ENGINEERING CHANGE NOTICE

1. ECN **605731**

HAZARD EVALUATION FOR TRANSFER OF WASTE FROM TANK 241-SY-101 TO TANK 241-SY-102

**HNF-3966
Revision 1**

Figure 3-1 SY-101 Transfer System HAZOP Node Diagram

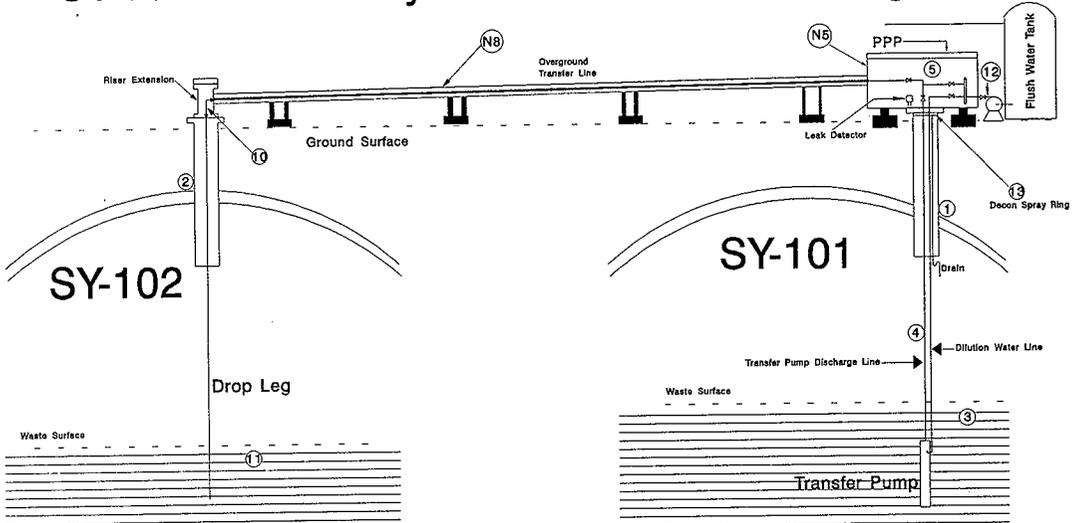
- Node 7: Deleted due to a change in design to utilize an overground transfer line and above ground PPP. This node was designated as encasement well in Tank 241-SY-101 new riser pit located at the low point of the line in HNF-3966 Rev 0. This node had a different designation during the initial HAZOP but was changed before issuing HNF-3966 Rev 0 due to a change in the design after the completion of that HAZOP. The original design had a swab riser outside the PPP assembly at the low point of the transfer line. A pit encasement well inside the new pit replaced the swab riser.

- Node 8: Only 1 hazardous condition was captured under this node. The hazardous condition has been altered to reflect generalized excavation concerns because of the change in design that utilizes an overground transfer line. In HNF-3966 Rev 0, this node was designated new transfer line tie-in to existing transfer line. Except for excavation concerns, this node has been replaced by supplemental HAZOP node 8N.

- Node 8N: Supplemental HAZOP New Overground Transfer Line (HNF-3966 Rev 1).
- Node 9: Deleted due to change in design. The use of an OGT has eliminated any intermediate pits, jumpers, or buried waste transfer lines. In HNF-3966 Rev 0 this node was designated new jumper in SY-B valve pit. Supplemental HAZOP node 8N has replaced this node.
